**SUBJECT: NRC ACCEPTED VERSION OF IMPROVED BPWS CONTROL ROD INSERTION  
PROCESS LTR, NEDO-33091-A**

**NEDO-33091-A  
Revision 2  
Class I  
DRF 0000-0008-3745  
July 2004**

# **Improved BPWS Control Rod Insertion Process**

**SUBJECT: SAFETY EVALUATION FOR LICENSING TOPICAL REPORT (LTR)  
NEDO-33091, "IMPROVED BPWS CONTROL ROD INSERTION PROCESS"  
(TAC NO. MB9642)**

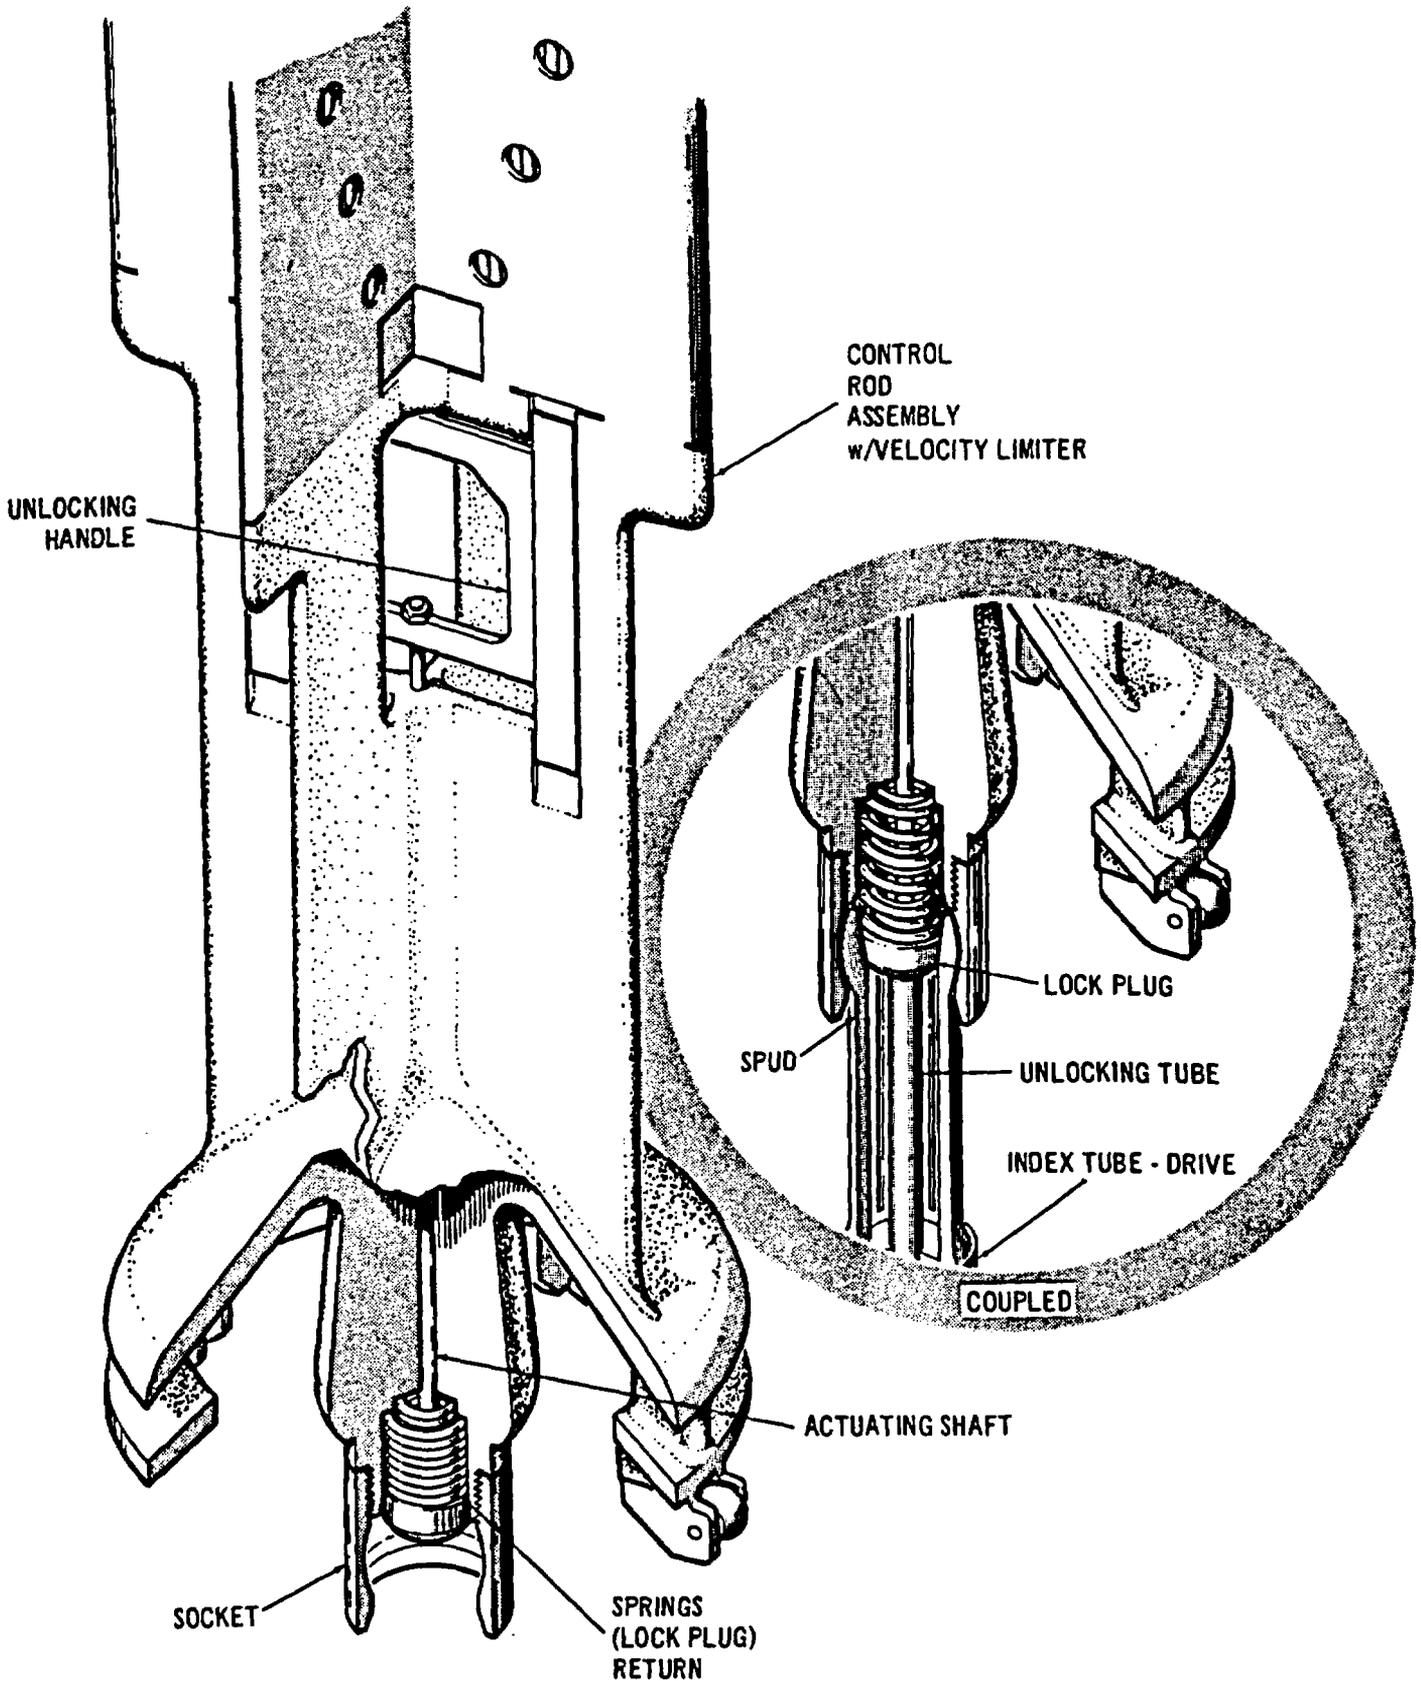
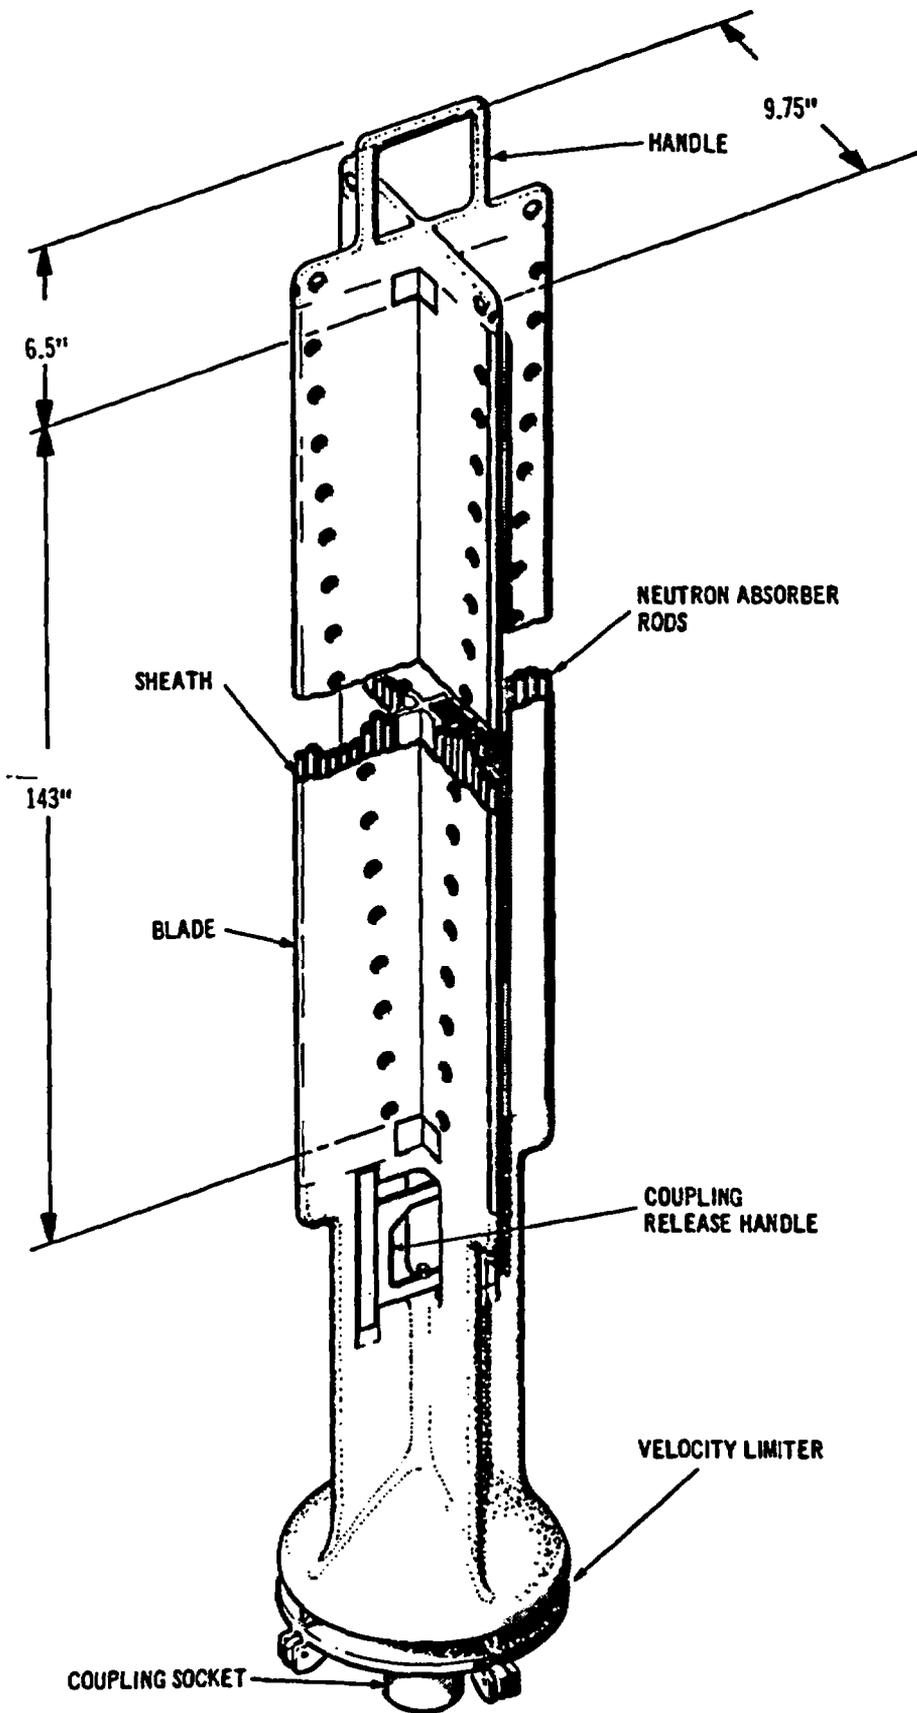
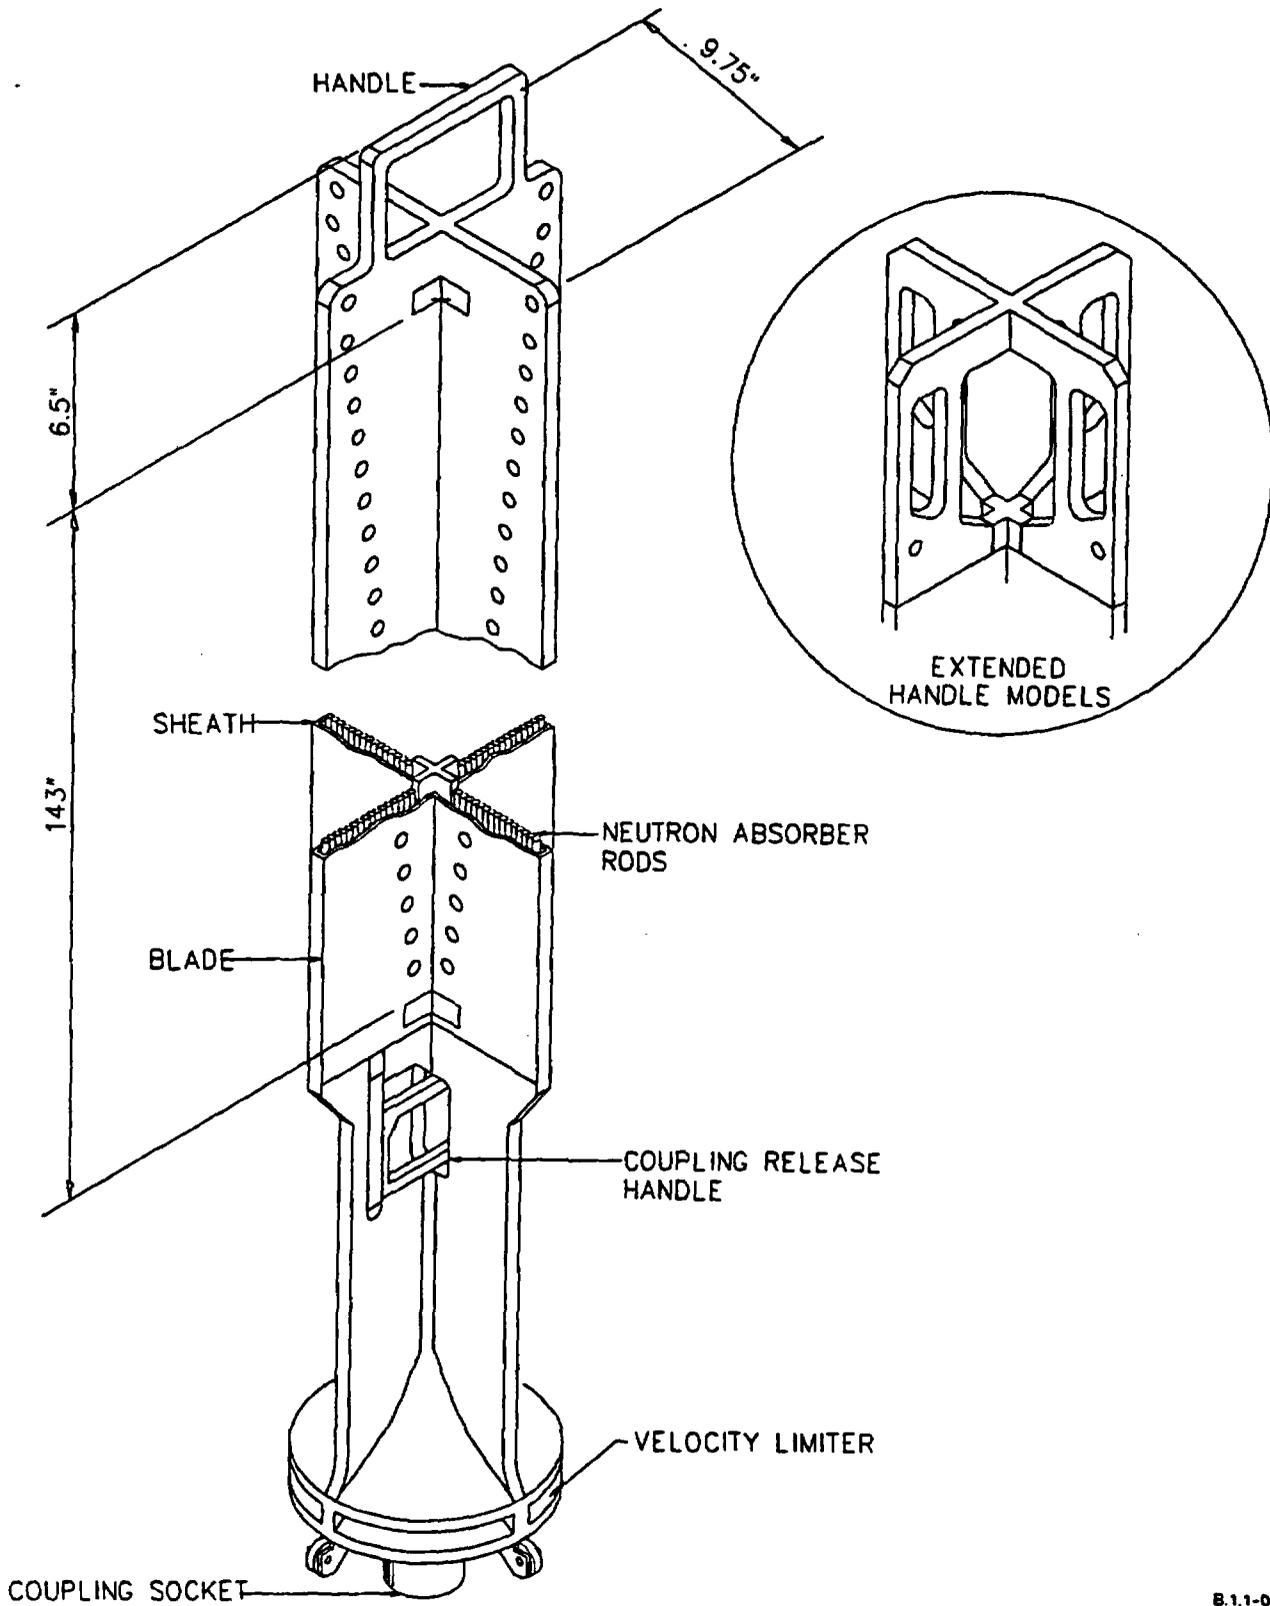
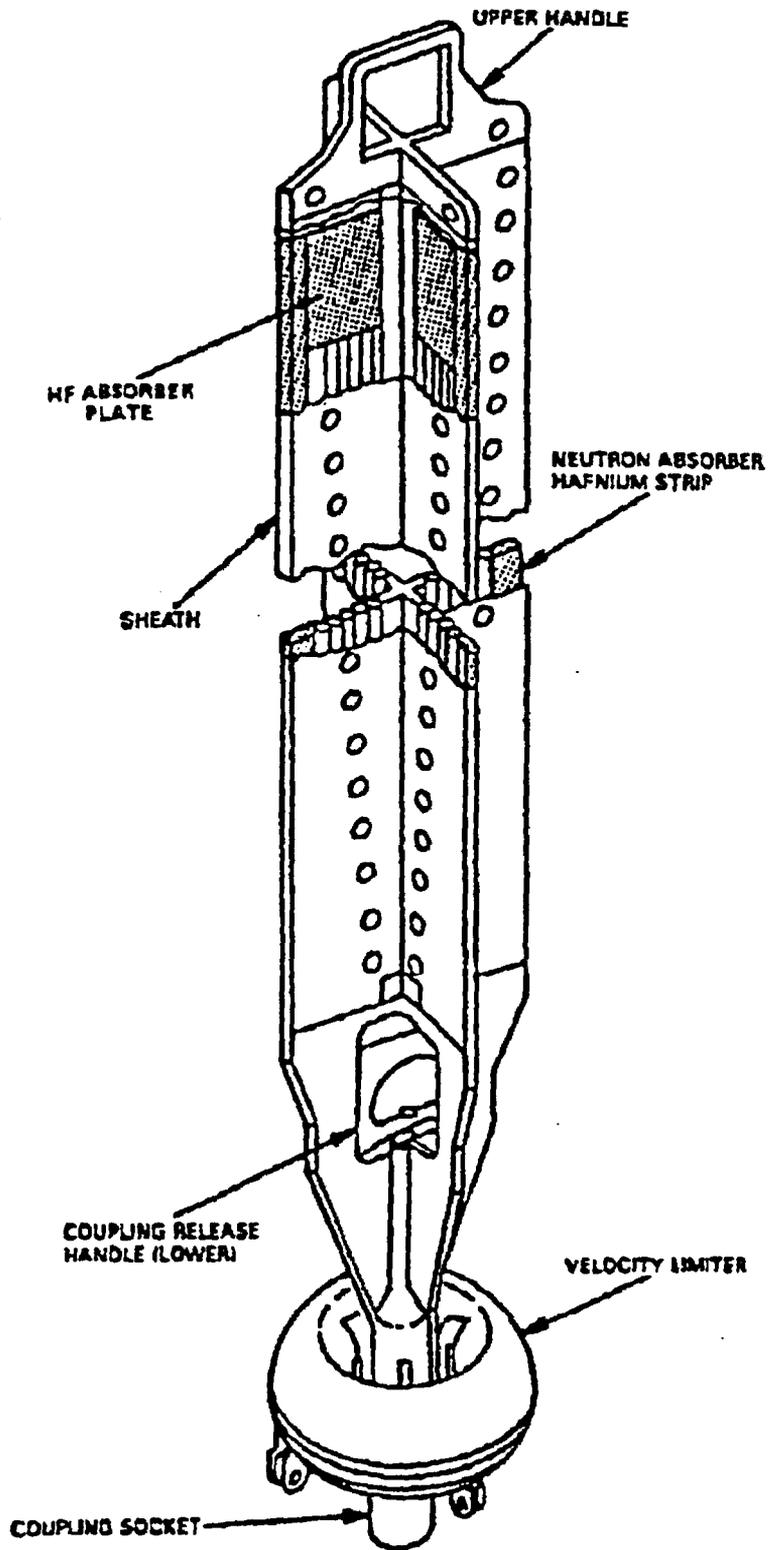
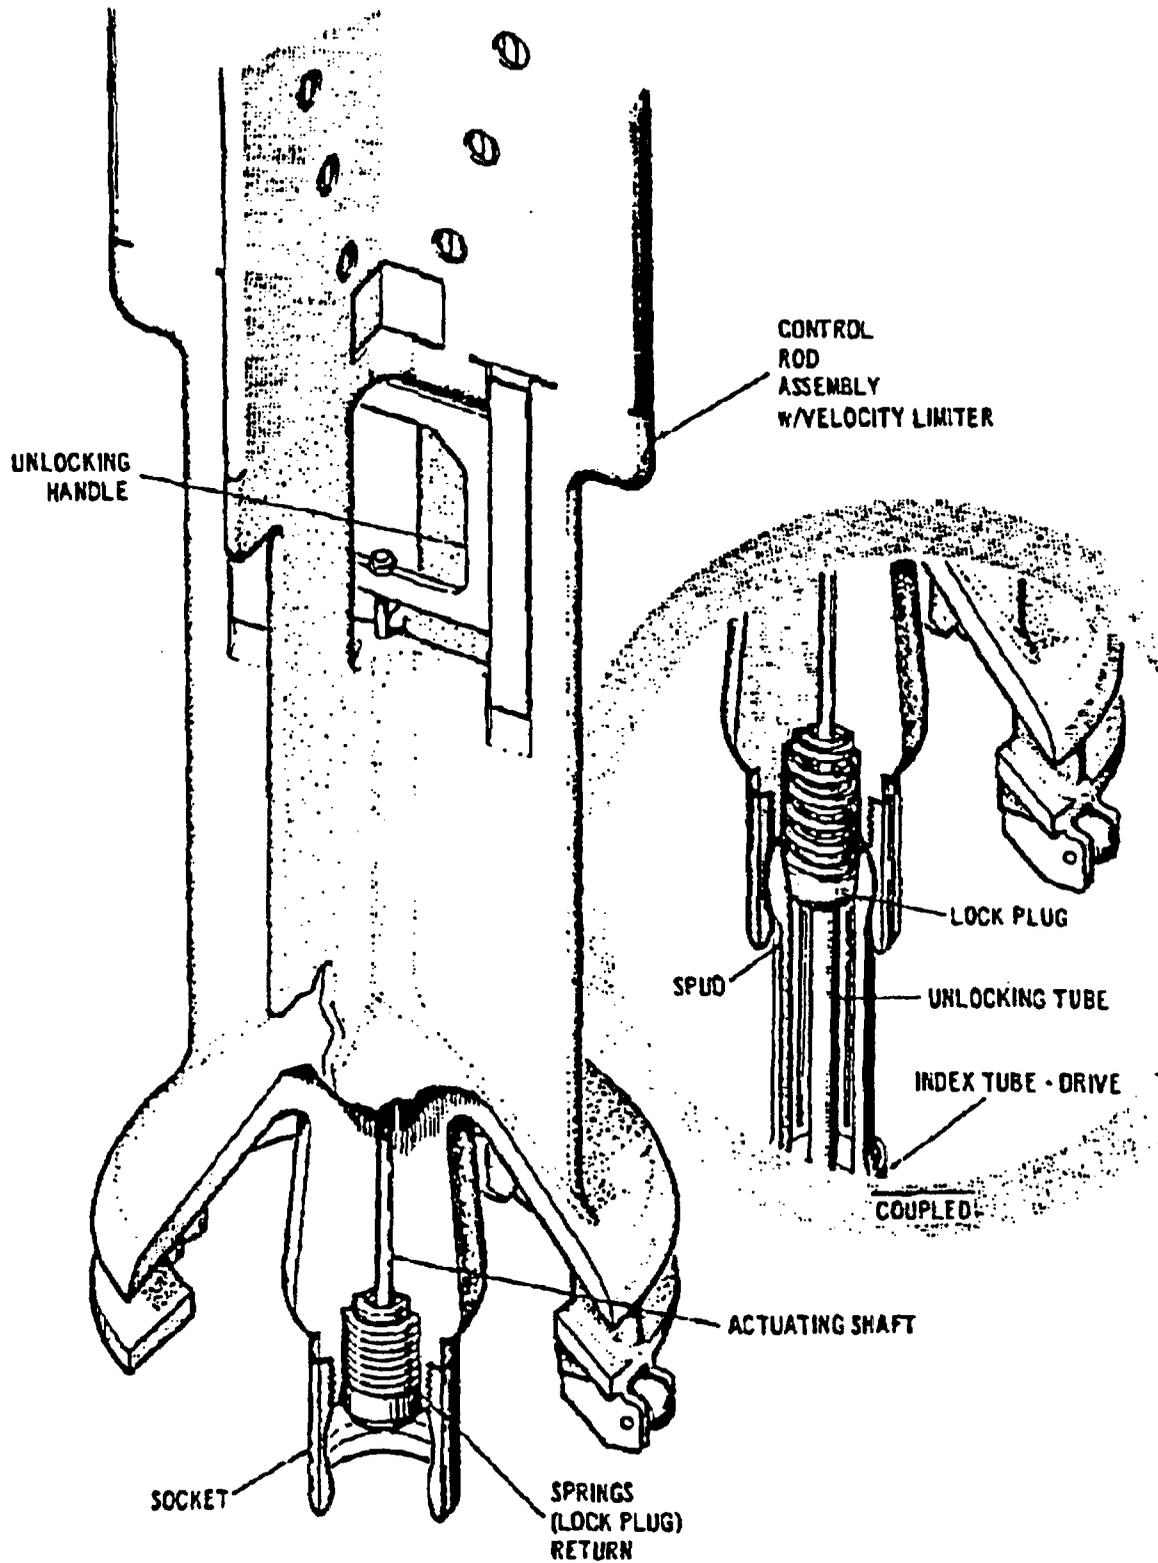
1. The LTR states that it is impossible for a control rod to become decoupled during the shutdown process following the improved BPWS. Please provide detailed information about the different types of control rod drives (CRDs) used for BWR-2 to BWR-6 plants with respect to the coupling between the CRD and control rod during shut-down. Based on this information, please also explain why it is not possible for the CRD and control rod to be decoupled.

All Reg. Guide 1.70, Rev.3 BWR UFSARs contain failure mode and effects analyses (FMEA) for the CRD system. Attachment 1 includes some pages from the FMEA in a typical BWR UFSAR (i.e., Limerick). As stated in the last paragraph of page 4.6-18, no single failure can of itself initiate a rod withdrawal. This statement is even more applicable, when the collet fingers are locked, such as when there is no CR movement or the CR is being inserted. (See Limerick Figure 4.6-3.) For a CR to withdraw, the six collet fingers must be unlocked so that the index tube can be lowered without being latched to a stop by the collet fingers. During CR insertion, if a mechanical/hydraulic failure occurs that stops all upward hydraulic force, the most the CR could withdraw is 6 inches to the next index tube latching indentation.

Attachment 1 also provides the UFSAR Control Rod Drive (CRD) and Control Rod (CR) design figures for a BWR/2 (Oyster Creek), BWR/3 (Monticello), BWR/4 (Limerick), BWR/5 (La Salle) and BWR/6 (Perry). For all BWR/2-6 plants, these figures demonstrate that a CR sits atop its associated CRD, and that it is physically impossible for a CR to move down past (i.e., to be withdrawn) its CRD.

Normally, a CR cannot become uncoupled from its CRD, because the CRD spud ("6-fingers") mechanically locks into the CR socket, and operator action is required to unlock this coupling. It is possible, due to a CRD assembly error, for a CRD to not properly lock into CR. In this case, CR movement (withdrawal and insertion) and scram are not impaired, because gravitational force will maintain the CR on top of its CRD. Plant Technical Specifications already provide provisions for coupling checks and steps to be taken if a CR is uncoupled from its drive.
